Title of Change:	ON Suzhou's DPAK and IPAK Case Outline Change from Non-JEDEC to JEDEC Standard.
Proposed first ship date:	19 June 2019
Contact information:	Contact your local ON Semiconductor Sales Office or <Jinman.Song@onsemi.com>
Samples:	Contact your local ON Semiconductor Sales Office or <PCN.samples@onsemi.com> Sample requests are to be submitted no later than 30 days from the date of first notification, Initial PCN or Final PCN, for this change.
Additional Reliability Data:	Contact your local ON Semiconductor Sales Office or <Lake.Wang@onsemi.com>
Type of notification:	This is a Final Product/Process Change Notification (FPCN) sent to customers. FPCNs are issued 90 days prior to implementation of the change. ON Semiconductor will consider this change accepted, unless an inquiry is made in writing within 30 days of delivery of this notice. To do so, contact <PCN.Support@onsemi.com>
Change Part Identification:	Customer may receive the DPAK parts with Jedec from month of June 2019 onwards once FPCN expire. Jedec parts can be identified through date code marking.

External Foundry/Subcon Sites:
 None
Description and Purpose:**Table 1: Old vs New Comparison for DPAK dimension.**

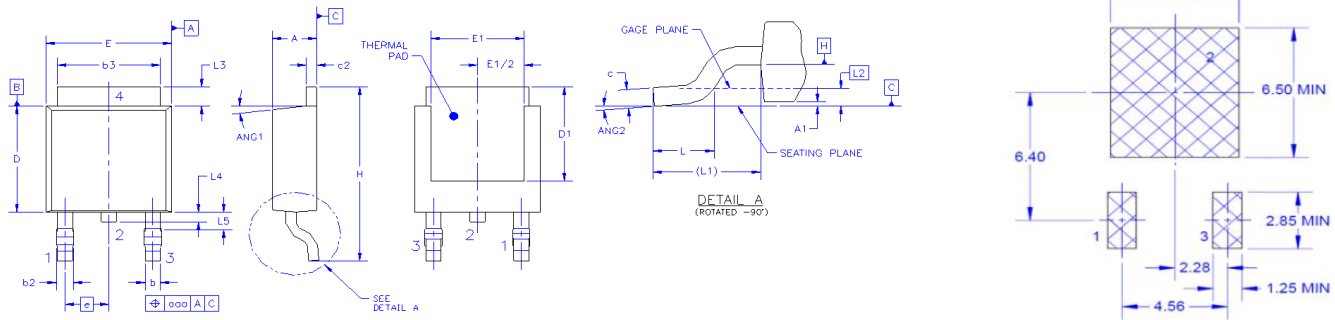
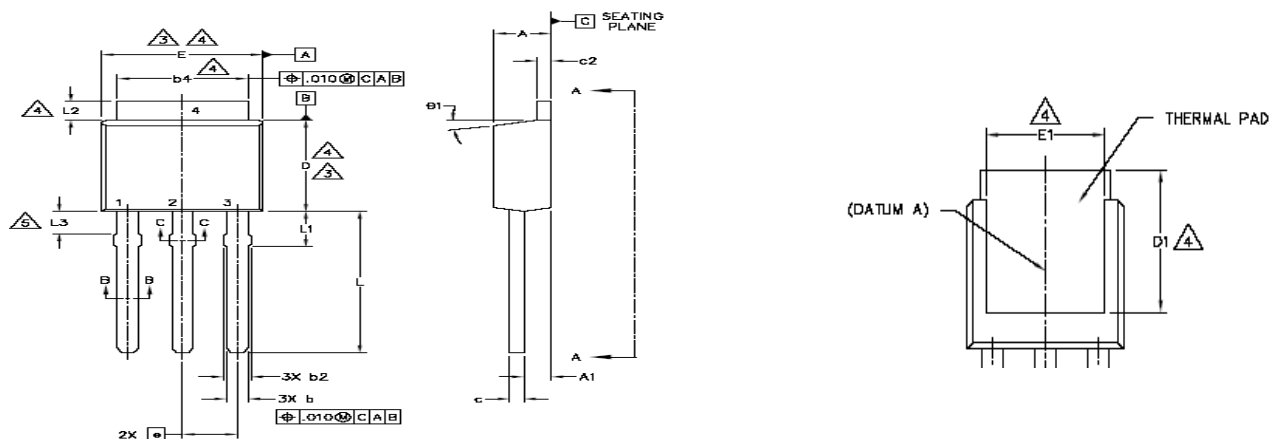
REF	DESCRIPTION	Old Dimension (DPAK NON-JEDEC)			New Dimension (DPAK JEDEC)		
		MIN	NOM	MAX	MIN	NOM	MAX
A	Package thickness	2.20		2.40	2.18	2.29	2.39
A1	Profile height	-0.050		0.20	---		0.127
b	Lead width	0.66	0.76	0.86	0.64	0.77	0.89
b2	Dambar cutting width			0.96	0.76	0.95	1.14
b3	Heat sink width	5.04	5.34	5.64	5.21	5.34	5.46
c	Lead thickness	0.40	0.50	0.60	0.45	0.53	0.61
c2	Heat sink thickness	0.40	0.50	0.60	0.45	0.52	0.58
D	Package length	5.900	6.10	6.30	5.97	6.10	6.22
D1	Back metal length	4.83			5.21		---
E	Package width	6.40	6.60	6.80	6.35	6.54	6.73
E1	Back metal width	5.040	----	5.640	4.32		---
e	Lead pitch	2.08	2.28	2.48	---	2.29	BSC
H	Total package length	9.20	9.50	9.80	9.40	9.91	10.41
L	Foot length	1.40	----	1.70	1.40	1.59	1.78
(L1)	Lead length	2.50	2.70	2.90	2.9ref		
L2	Gage plane	0.490	0.50	0.510	---	0.51	BSE
L3	Heat sink height	0.50		0.90	0.89	1.08	1.27
L4	Center lead cut length	----	----	----	0.64	0.83	1.02

L5	Dambar distance to pkg edge				---	---	---
ANG1	Package draft angle	----	----	----	---	---	---
ANG2	foot landing angle	----	----	----	0.00	---	10.00
aaa	Lead position tolerances	---	---	---	---	---	0.25
